September 23, 2016

Re: Energy Conservation Program: Test Procedures for Central Air Conditioners and Heat Pumps – Supplemental Notice of Proposed Rulemaking, Docket No. EERE–2016–BT–TP–0029

COMMENTS

Figure 1

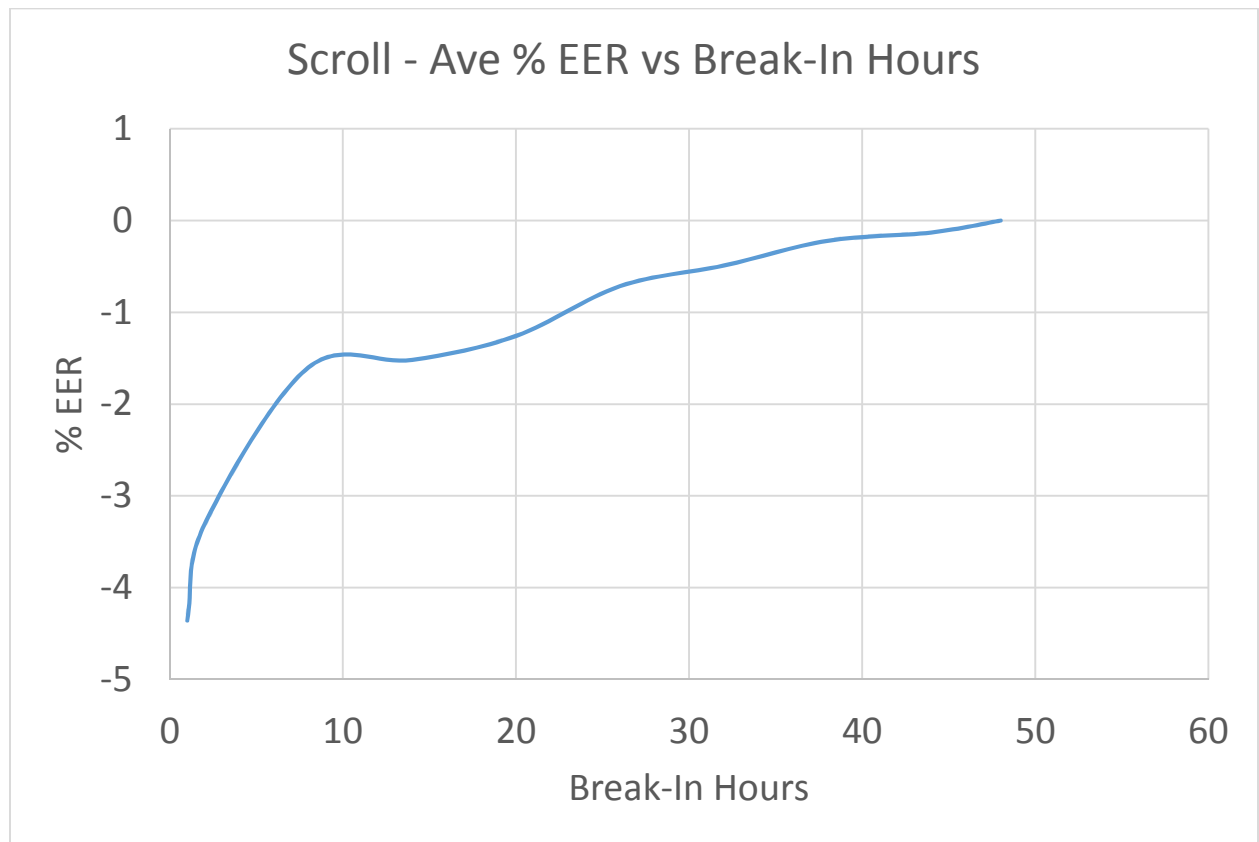
Further, two compressor manufacturers supplied data for scroll compressors, shown in Figure 1, below. Testing to collect this data was conducted at ambient temperature.

While the above data shows that full performance was reached after 50 hours, all of the discussions regarding break in been focused on the rating point of the compressor, but at lower load points the run-in can be longer. For small unitary SEER rating, capacity is determined at full load, but the EER for SEER is measured at the low load point. In fact, one manufacturer provided data for a smaller, but standard, scroll compressor that would typically be used in a 3-ton CAC, Figure 2, below, that even after 250 hours did not reach full performance. The data, taken from tests of 3 compressors, is from calorimeter testing at 45 °F evaporating temperature at dew point, 100 °F condensing temperature at dew point, 20 °F superheat, and 15 °F subcooling reflects typical conditions where the EER rating of small unitary equipment is measured.

AHRI suggests that DOE extend the break-in period to 72 hours to allow for accurate EER ratings and permit the break-in to be conducted at ambient conditions, outside the test cell. Not all manufacturers will request a 72-hour break-in period, but the option should be available for those manufacturers who need this time.

Figure 2

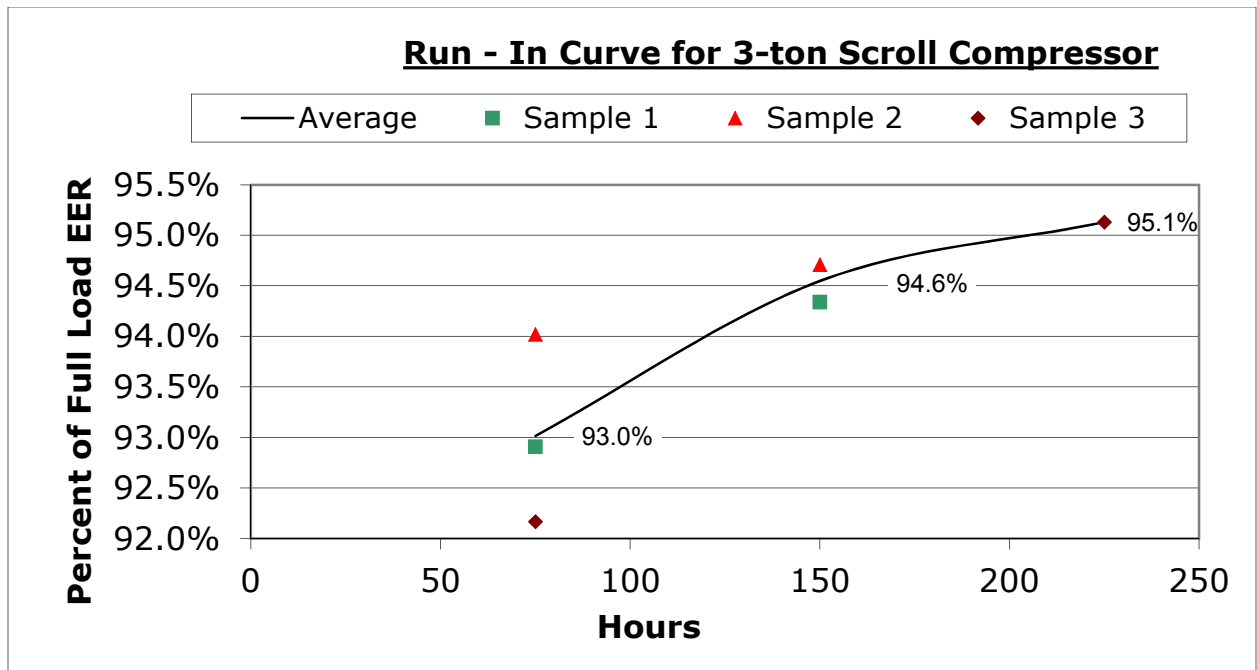
Another benefit to extending the time allowed for compressor break in is to reduce the standard deviation of the data, a very important feature to providing customers with accurate performance ratings. AHRI would like to remind the Department that manufacturers also need to be able to manage non-standard components, including compressors, for certain products.
